LOWER MINNESOTA RIVER WATERSHED DISTRICT

Lower Minnesota River Watershed District Board of Managers Meeting

Technical Memorandum

Re: Spring Creek Hydrology Review

Figure 20. Carver SWCD 2019 proposed design for Site 1 (112 5th Street West)

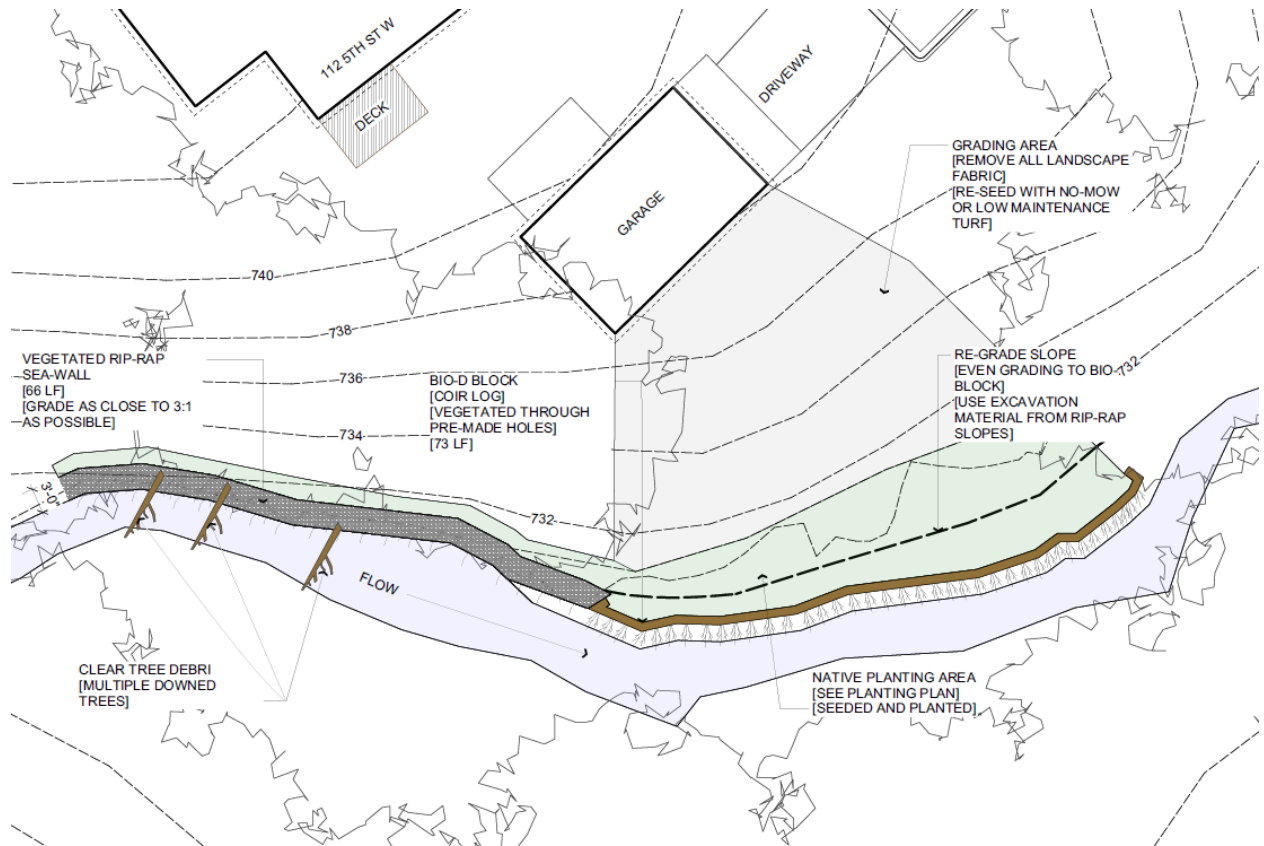
The SWCD has proposed vegetated riprap and Bio-D block walls with native plantings along the left bank at Site 1 to prevent Spring Creek from further eastward migration (Figure 20), at a cost of approximately \$75,000. For Site 2, the SWCD recommended a more robust combination of riprap, Bio-D block, native plantings, and removal of the failing concrete walls (Figure 21), at a cost of approximately \$88,000.

Still assuming the same underlying sandy loam soils comprise the creek banks but are vegetated with short native and bunch grasses as was observed in the field, Site 2 is stable, however Site 1 would be expected to show signs of erosion (as it does currently). The proposed SWCD designs of Bio-D block walls and riprap should be sufficient to withstand the expected velocities and stresses under the current conditions. We recommend evaluating the size of the riprap to ensure it can withstand the expected velocities at Site 1.

- The structures at Site 1 do not appear to be under immediate threat from Spring Creek. We recommend reevaluating the need for stabilization pending the results of the monitoring and vegetation management study.

- While the Carver SWCD designs appear to be appropriate with slight modifications to the riprap sizes, rather than embark upon single restorations for these individual landowners, we recommend that the District reach out to all Spring Creek landowners in this reach to determine if there is interest for a larger project and how long and where this erosion has been occurring.

Figure 21. Carver SWCD 2019 proposed design for Site 2 (404 Broadway)

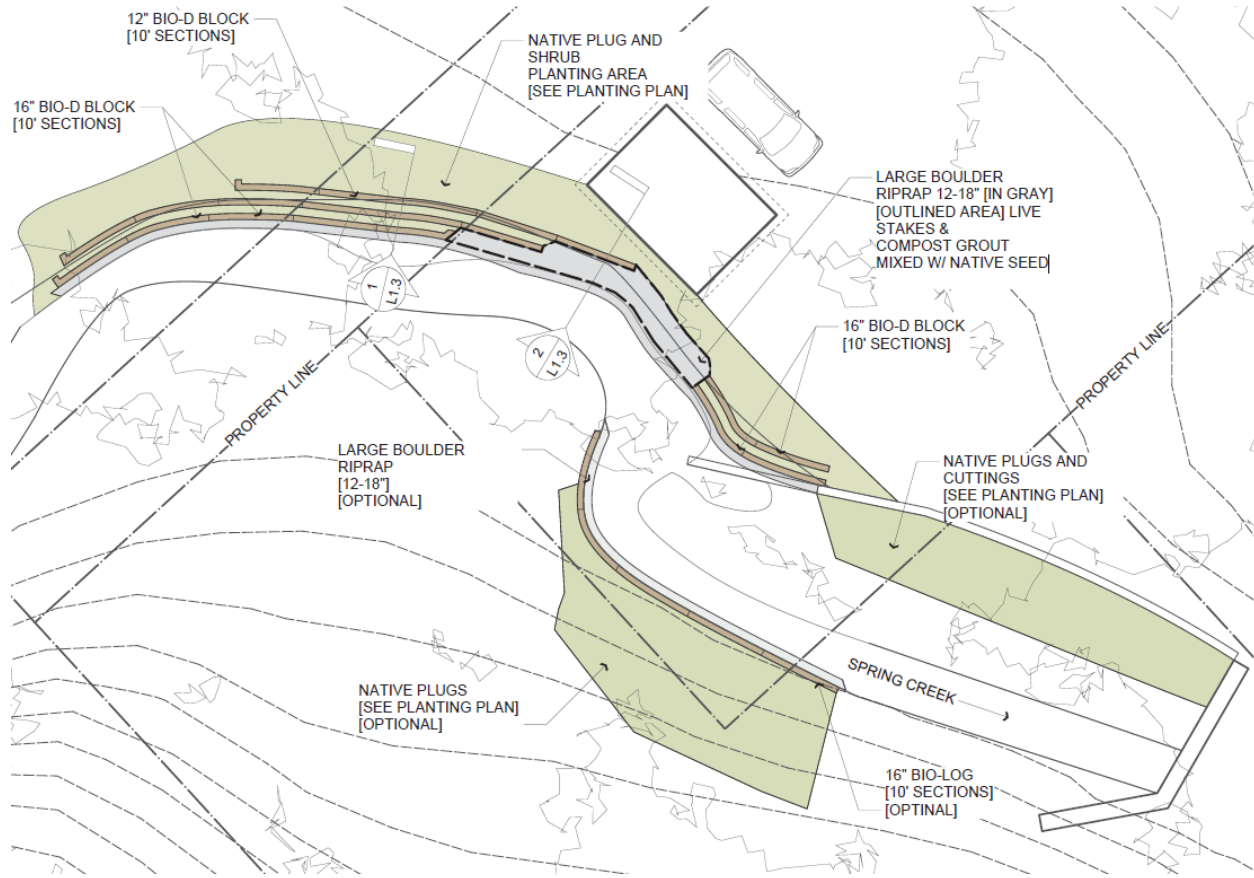
Similar to the presettlement conditions, floodwaters at Site 1 are not expected to encroach upon the garage under the current Spring Creek hydrology; but at Site 2 the garage can be expected to be flooded from the 10- and 100-year events.

- The SWCD design for Site 2 is appropriate with an increase in riprap size

- combined with a standard gradation.
 - Stabilization designs for 112, 116, and 200 4th Street West (Site 3) have not yet been developed. We recommend reaching out to the property owner and Carver SWCD to conduct a site survey and determine the level of interest for a valley stabilization effort first, then complete a feasibility study to determine the best approach.

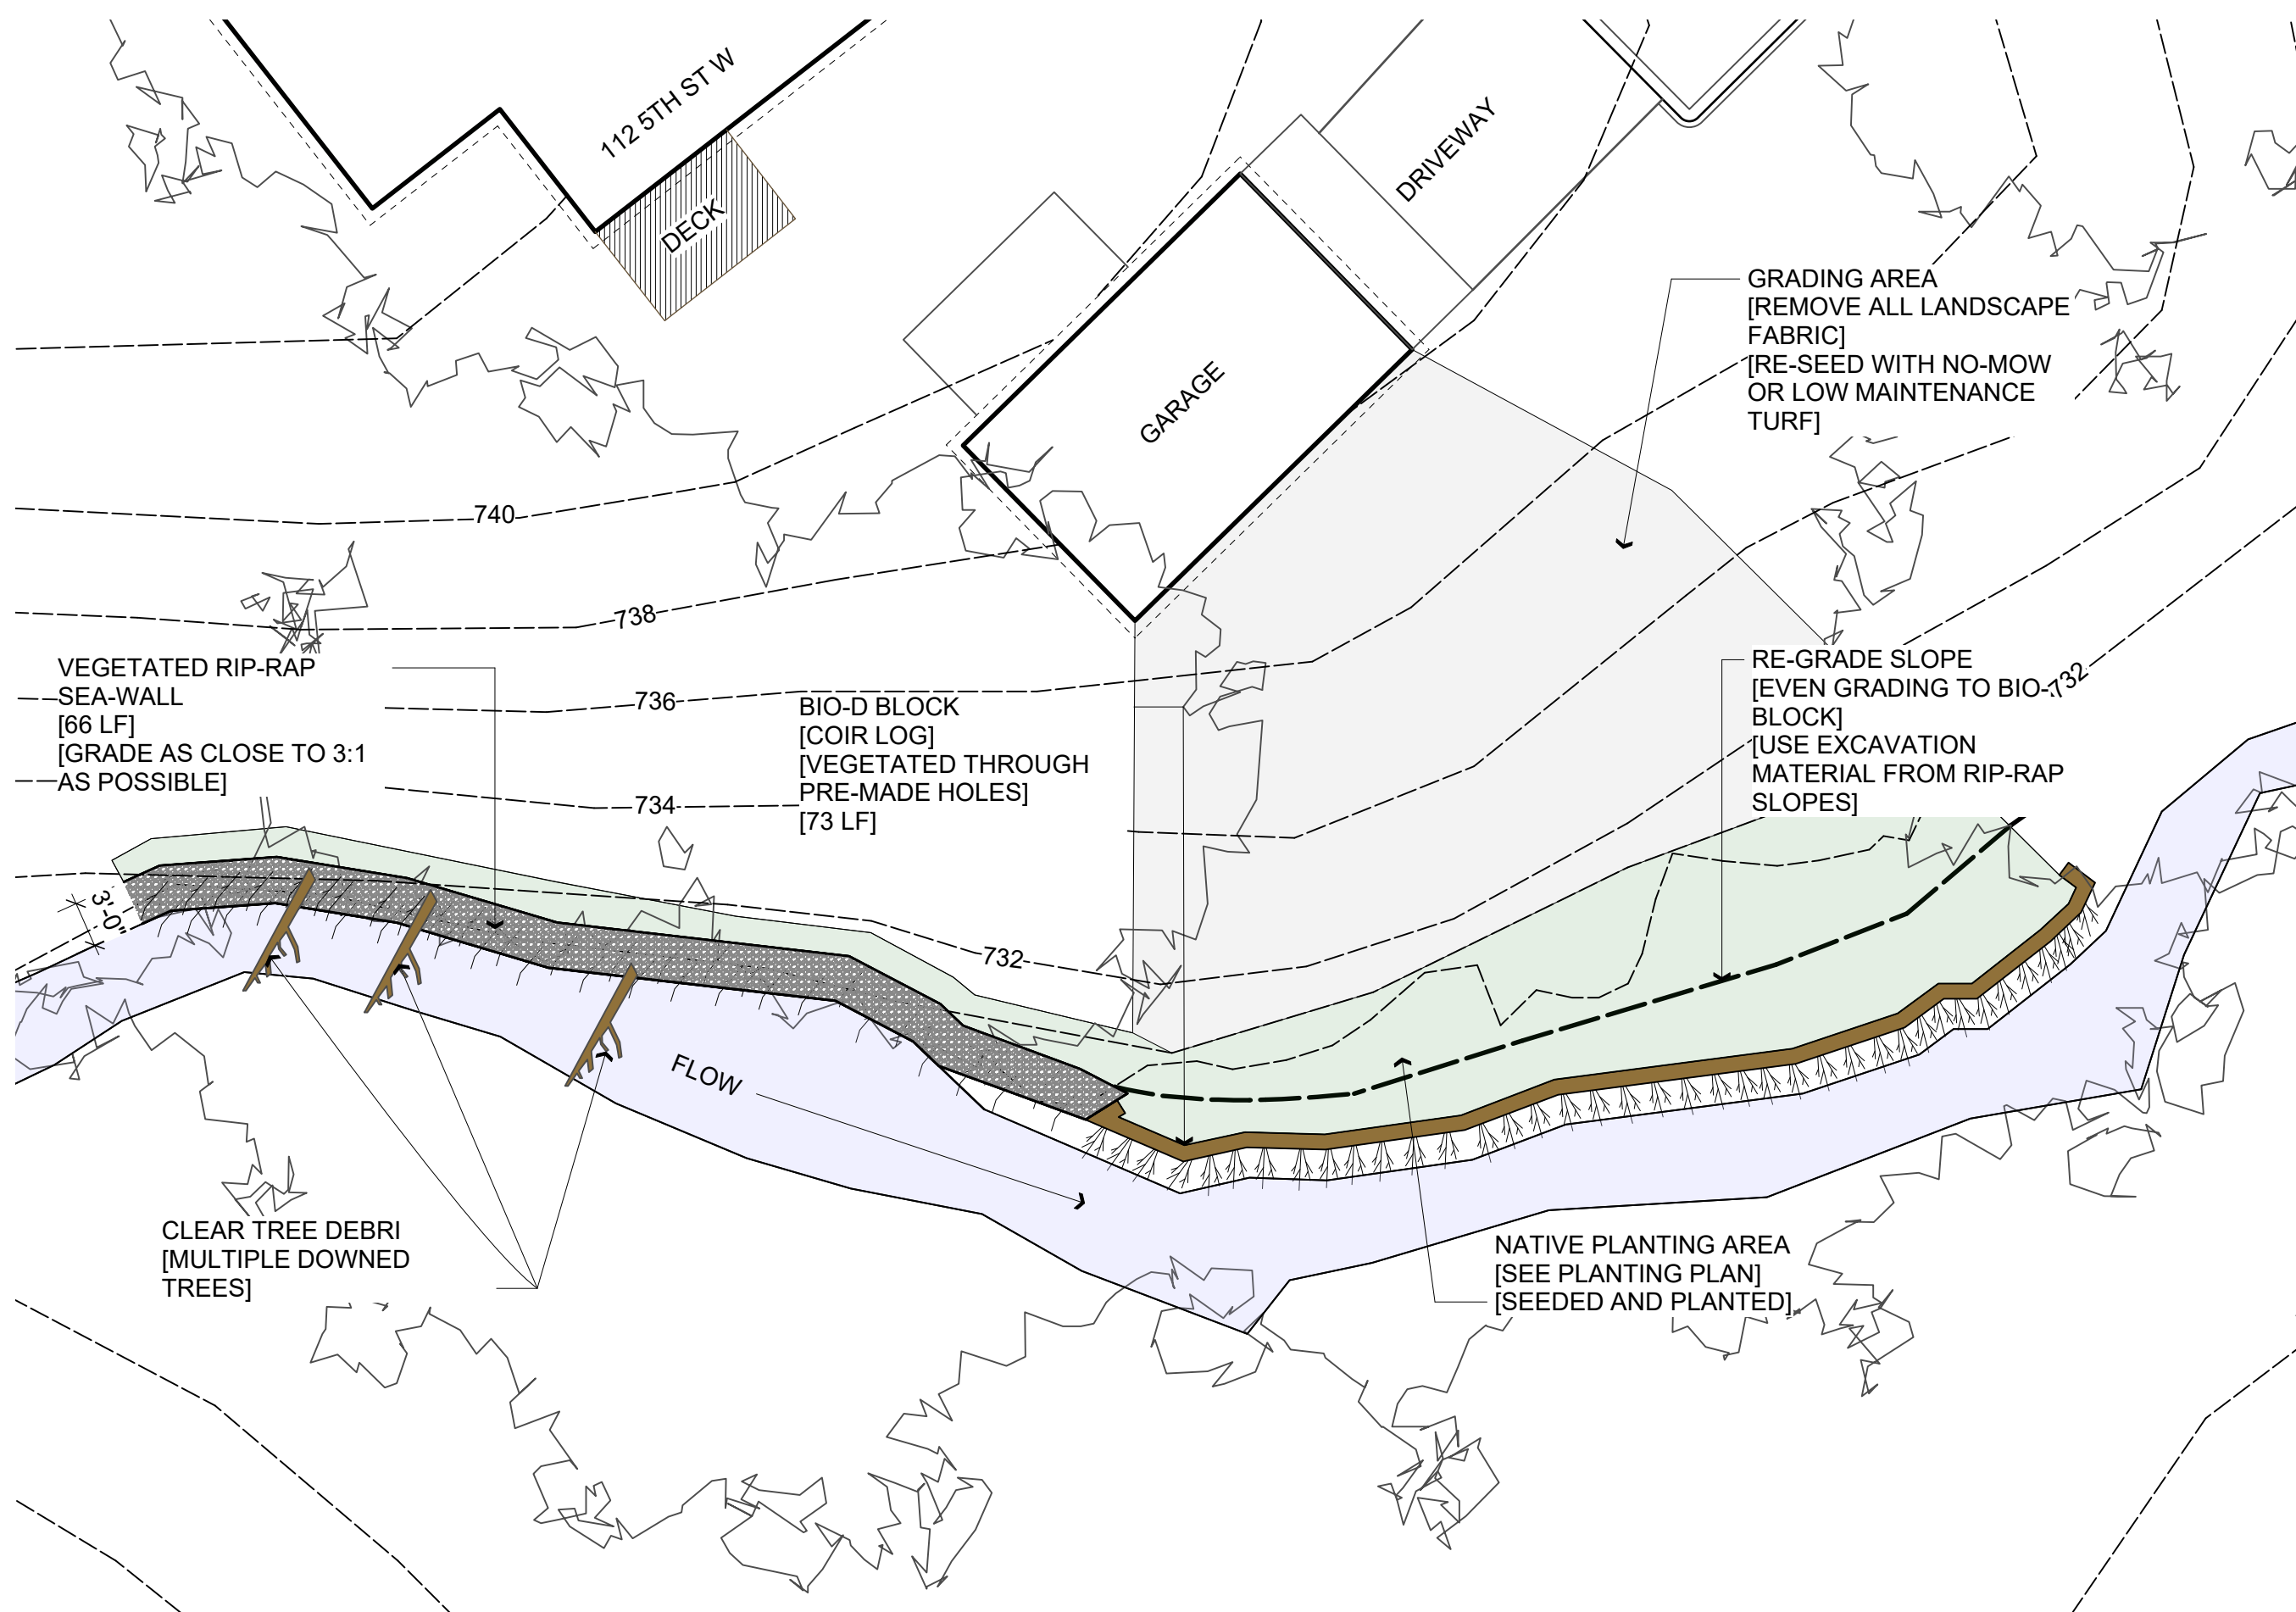
The Carver SWCD concept plan includes removing fallen trees, using riprap to armor the channel where banks are eroding, and revegetating with deep rooted species. Barr concurs with the general concept with the following considerations:

- 1) Additional assessment of the hydrology should be completed to better understand potential changes that have already occurred and may occur into the future, and to help design stabilization measures.
- 2) Cross vanes should also be installed to provide additional grade control. They may also be used to elevate the stream bed to reconnect the stream to the former floodplain.
- 3) If the cross vanes cannot completely restore a floodplain connection, then additional grading should be considered to create a floodplain.

- At 404 Broadway, restore the channel to the previous alignment, which will provide additional space between the garage and the creek.
- Restore the previous channel alignment at 112 5th Street, with consideration of the modified hydrology draining to this location.
